AGENDA
HISTORIC DISTRICT COUNCIL
REGULAR MEETING -VIRTUAL
THURSDAY, SEPTEMBER 17, 2020
5:00 PM
CITY HALL COMMISSION CHAMBERS
204 ASH STREET
FERNANDINA BEACH, FL 32034

- 1. CALL TO ORDER / ROLL CALL / DETERMINATION OF QUORUM**
- 2. APPROVAL OF MEETING MINUTES**
- 3. OLD BUSINESS**
 - 3.1 HDC 2019-37 - MARK AKINS, RICE ARCHITECTS, AGENT FOR FIRST PRESBYTERIAN CHURCH OF FERNANDINA BEACH, 515 CENTRE STREET**
Certificate of Approval (COA) to renovate the south and east elevations and add a rooftop terrace with canopy. *(Quasi-Judicial)*

Owner/Applicant:	Rice Architect, agent for First Presbyterian Church Fernandina Beach
Property Address:	515 Centre Street
Requested action:	Certificate of Approval (COA) to renovate the south and east elevations and add a rooftop terrace with canopy.
Current zoning:	C-3
FLUM land use category:	Central Business District
Existing uses on the site:	Commercial
FL Master Site File #	8NA01098
Year Built:	1957 (FMSF)
Contributing Status:	Non-Contributing

LEFT SIDE ELEVATION - MAIN HOUSE
Scale: 1/4" = 1'-0"

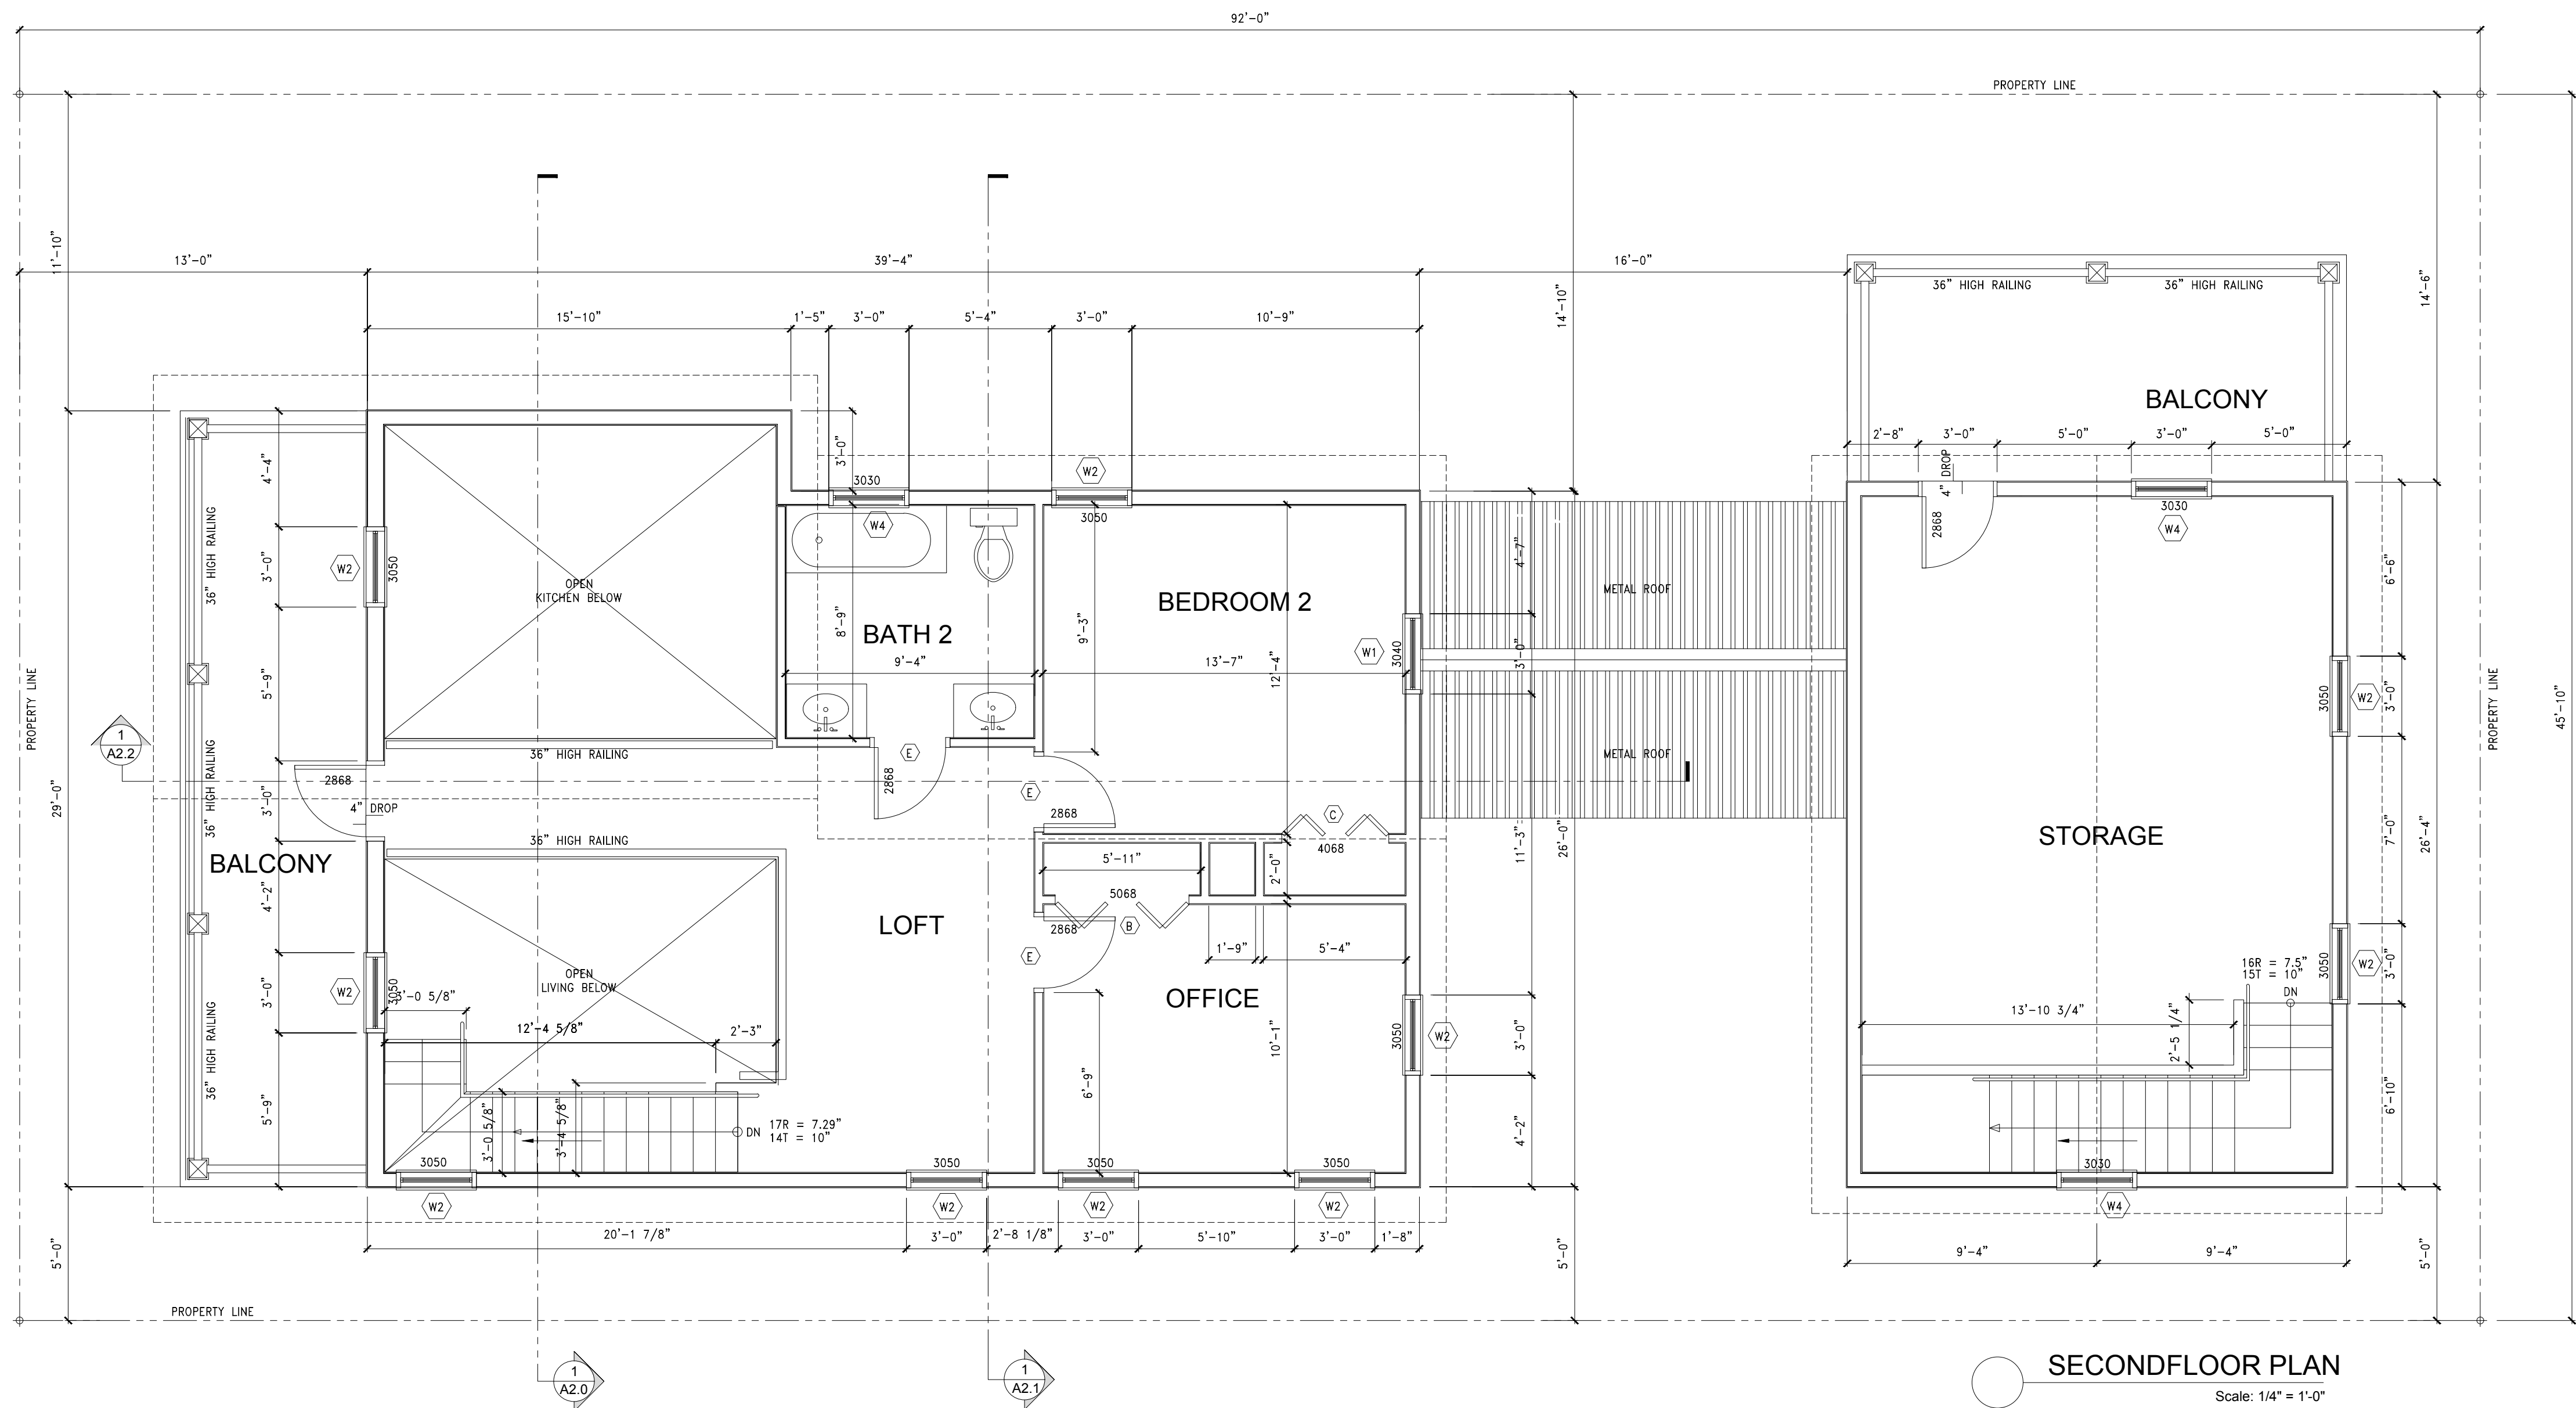
1. altering the roof pitch to bring the roof height down to 24';
2. moving door on east side elevation to the second floor;
3. removing ground floor window on west elevation;
4. adding window at second floor of east elevation; and
5. change carport to second floor deck.

At a current height of 25' 1", the accessory structure is above the permissible height. The requested modification to the roof pitch would bring the structure into compliance.

All other modifications requested do not have a negative impact on the project and meet all LDC and Design Guidelines.
